Planning Commission
July 20, 2021 – 6:00 p.m.
233 South Main Street, Monroe, Ohio

TO: Members of the Monroe Planning Commission
FROM: Kevin Chesar
Director of Development

DATE: July 20, 2021
RE: Information Packet for July 20, 2021 Planning Commission Meeting at 6:00 p.m.

I. Case No. 2021-1-1 (TABLED)—Consideration of a Site Plan for Thornton’s

SITE PLAN

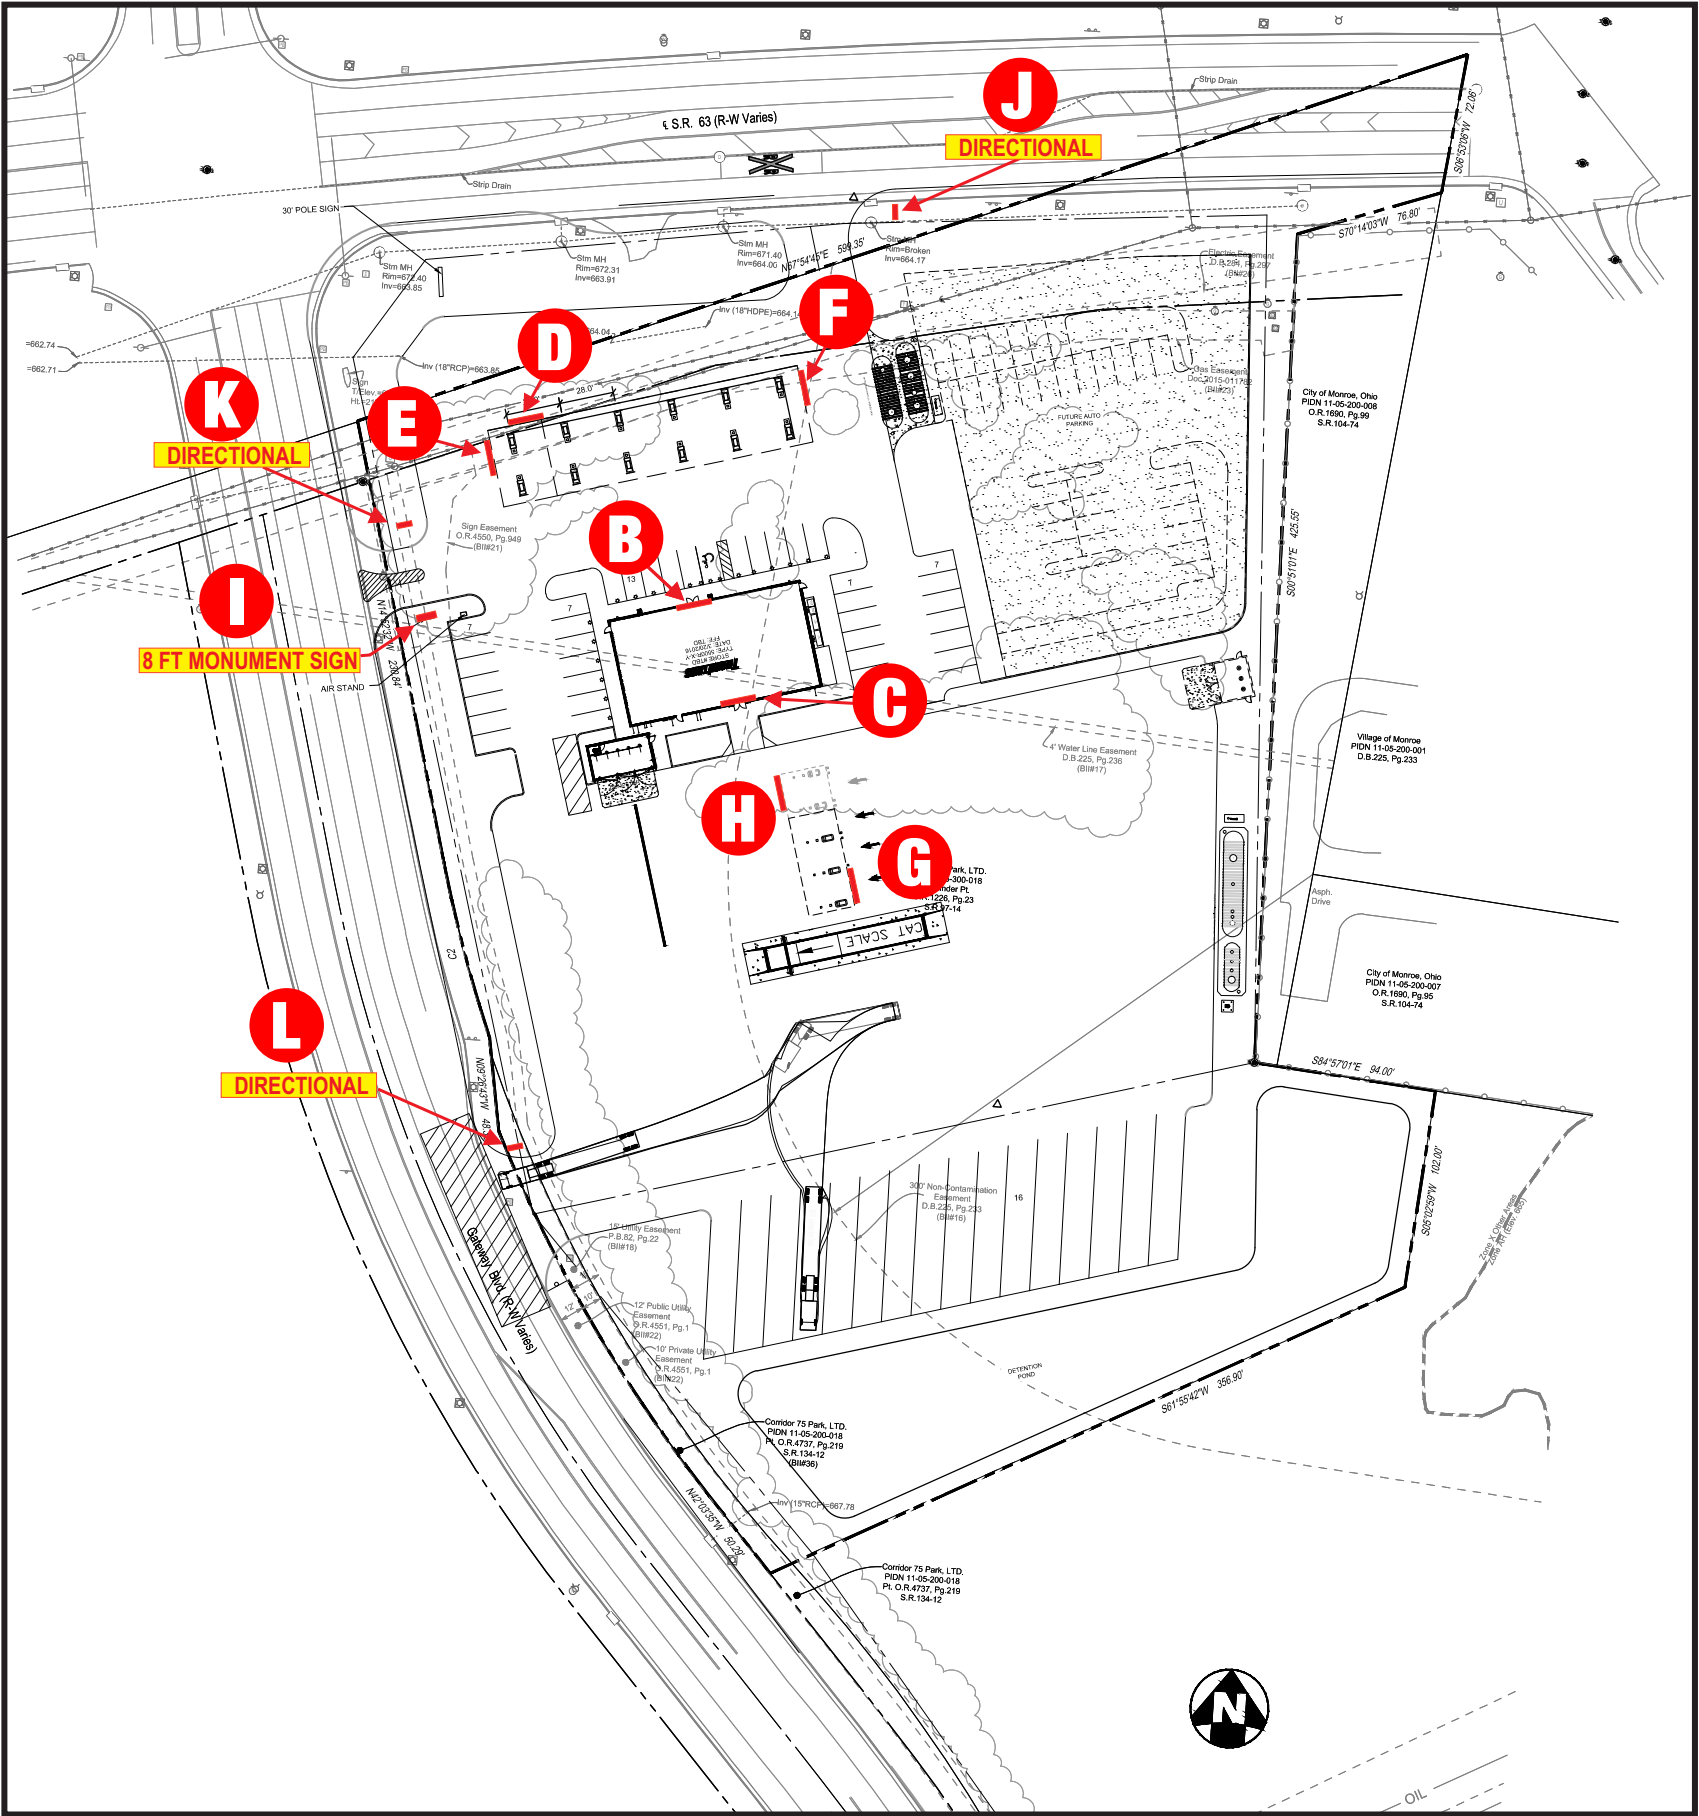
26. Comment: Pole sign is prohibited in the C-2 zoning district. While not discussed in particular at the most recent meeting with the applicant, it is Staff's understanding Thorntons will seek a variance for this signage through the Board of Zoning Appeals. This process will have to occur prior to sign permits being filed. For purposes of site plan approval through Planning Commission, the sign will need to be removed from all plans or otherwise noted on plans as not approved and will need to seek separate Board of Zoning Appeals approval after site plan approval.
